TVHS Murfreesboro - Replace Chiller and Cooling Tower VA Project # 626A4-14-201 Addendum #1 05-26-2016

This Addendum, dated 5-26-2016, serves to clarify, revise, and supersede information in the Project Manual, Drawings, and previously issued Addenda. Portions of the Addendum affecting the Contract Documents will be incorporated into the Contract by enumeration of the Addendum in the Owner/Contractor Agreement.

REVISIONS TO DRAWING SHEETS:

- - - E N D - - -

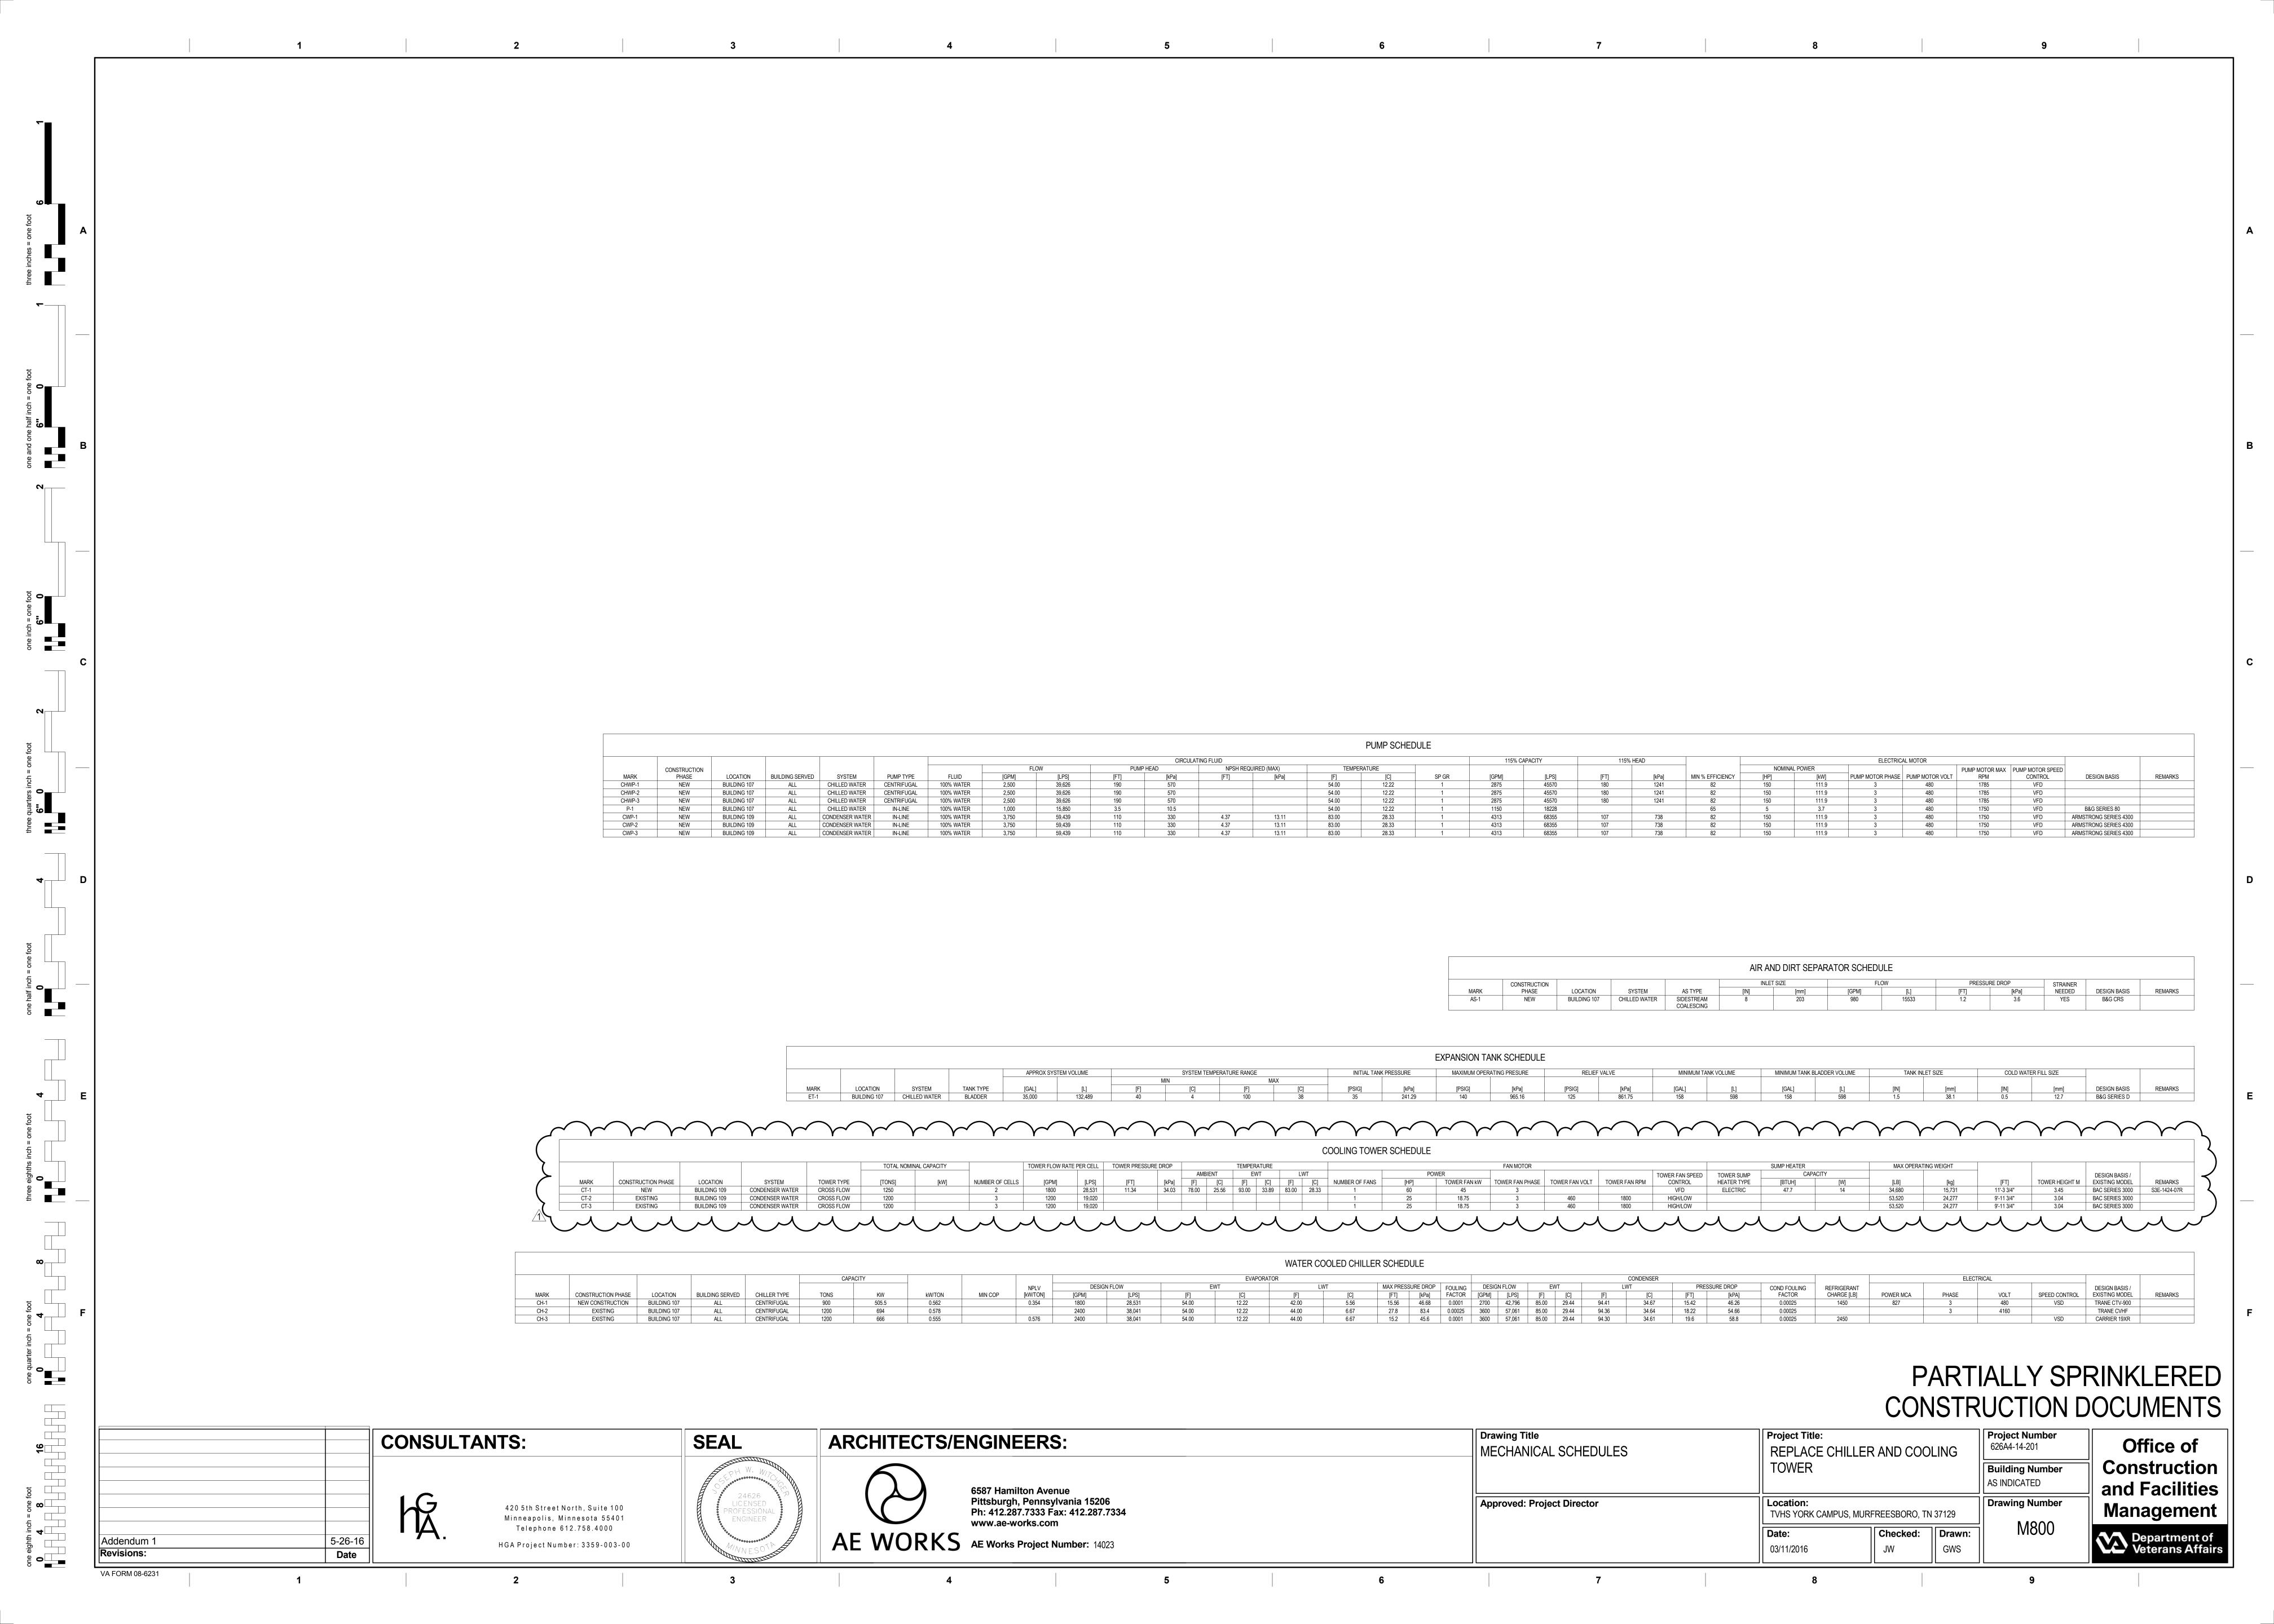
1. Relocated Adams strainer includes relocating drains, controls identified on plans. Clarification of new air separator and piping made to 6/M101.

- 1. Top of new cooling tower sumps must be equal to top of existing cooling tower sumps. See added note to document.
- 2. New reducer may be required depending on location of buried 18x12 reducer underground at towers. Contractor to field verify.
- 3. Modification of flexible metal shielded expansion devices will be used at towers. Change shown on drawing.
- 4. CWR and CWS pipe sizes switched. Piping shown as 14" CWR and 16" CWS on drawing.
- 5. Manual water make up shown on schematic (M601) added to drawing.

- 1. Installation of equipment must be installed in accordance with manufacturer's requirements. Changes to details for compliance shown.
- 2. Refrigerant venting depends on chiller selected. R-123 chiller shall use Trane Rupture Guard safety valve. See detail 9/M500 for revised requirement.

3. Snubbers are not required at pressure gages as called out, utilize ½" ball valves as shown on details.

- 1. Air separator to include auto air vent isolated by manual ball valve, drain with blowdown valve.
- 2. Modifications to match changes made to plan and details.

1. Modify cooling tower schedule as shown. Equipment TOTAL NOMINAL CAPACITY does not change, number of cells and flow per cell updated to match actual.

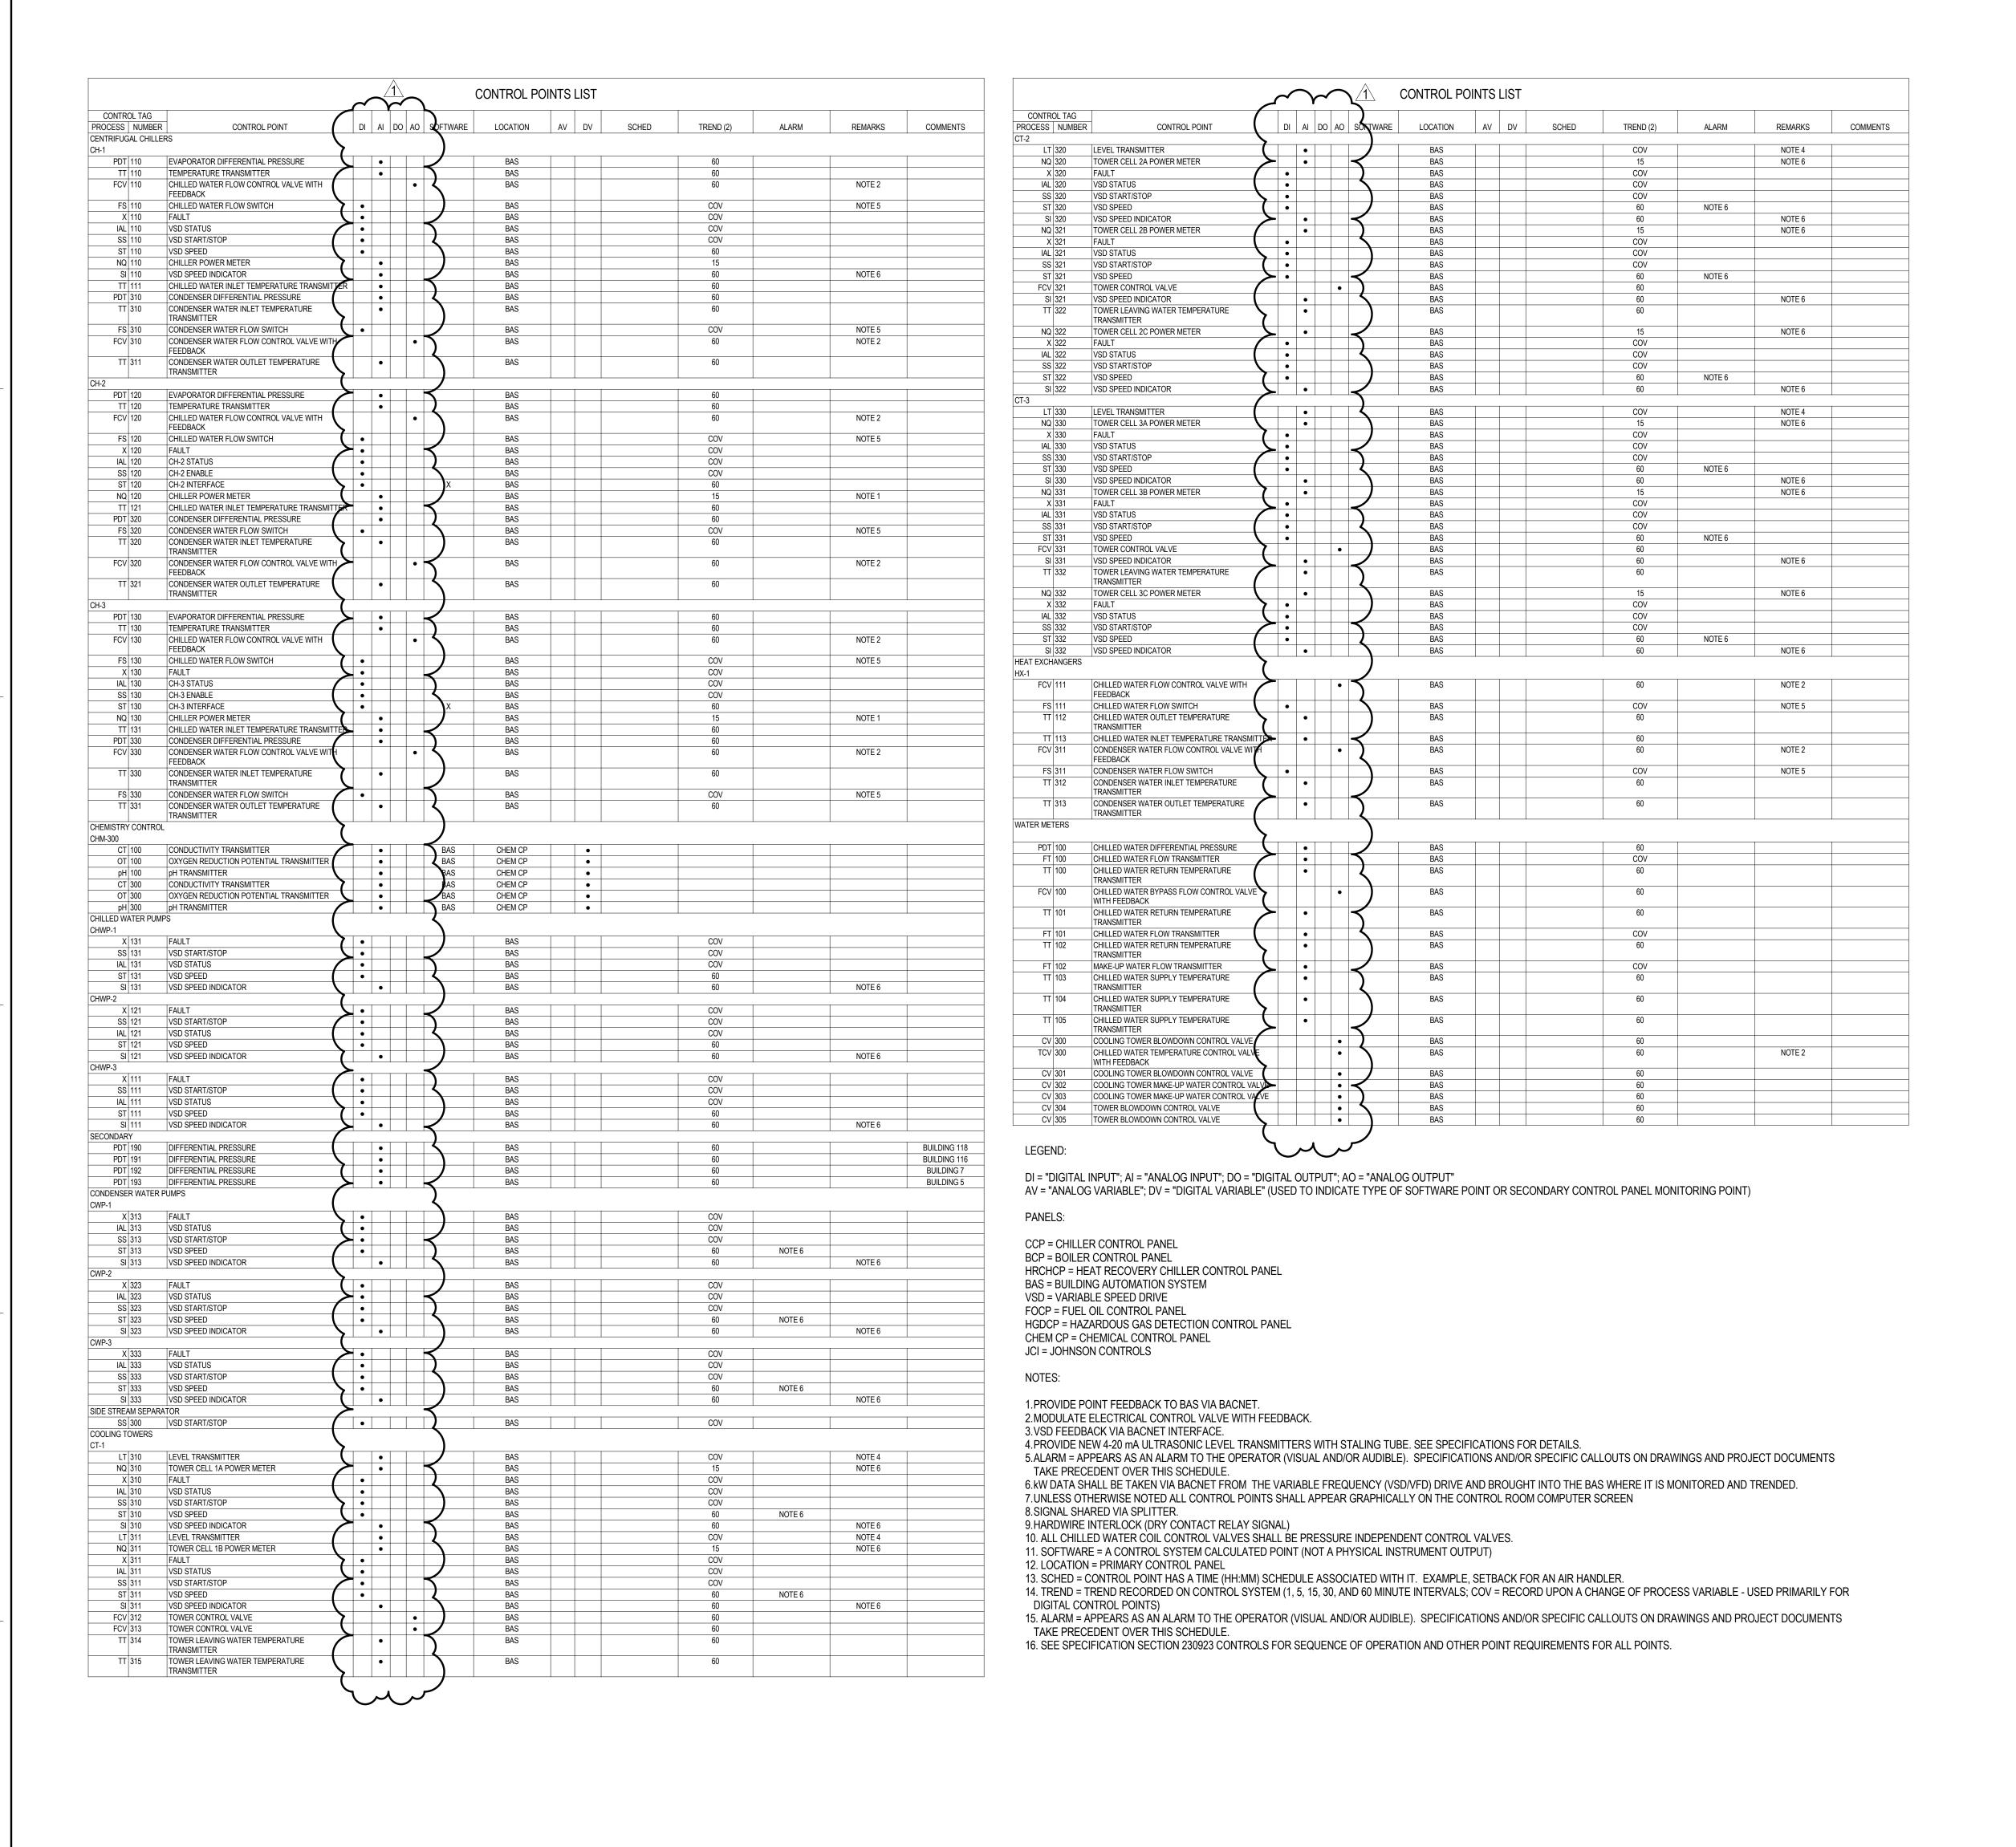
1. Modify control point signal requirement as shown on drawing.
